# COMMITTEE OF ADJUSTMENT

## MINOR VARIANCE REPORT

APPLICATION: **CAV A/031/2024**

**CAV A/031/2024 - 1329 Thornhill Drive (West District) (OP Designation: Low Density Residential)**

Site Plan showing the proposed balcony highlighted

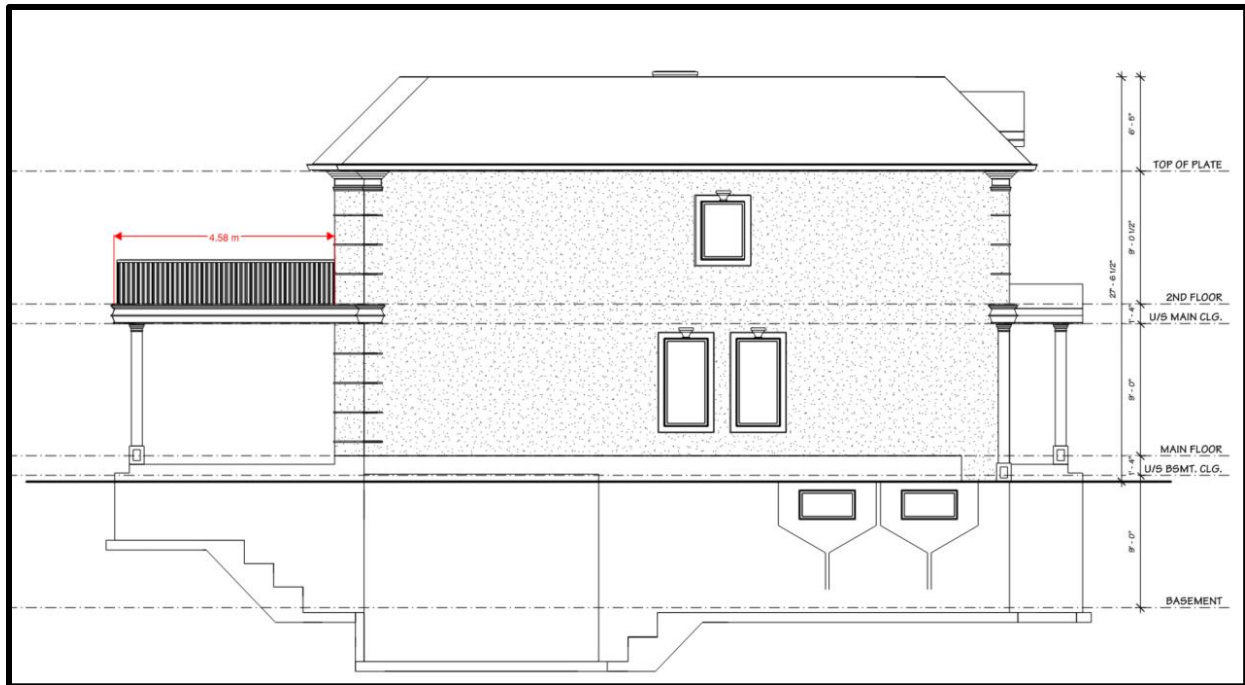
The proposed second-floor balcony is approximately 20 m<sup>2</sup> (218.75 ft<sup>2</sup>) in size and projects approximately 4.58m into the rear yard beyond the main wall of the dwelling with access from the master bedroom. This large balcony results in significant overlook and privacy concerns for adjacent properties.

In staff's opinion the proposed variances do not meet the general intent and purpose of the Zoning By-law and would create a negative impact on adjacent properties.
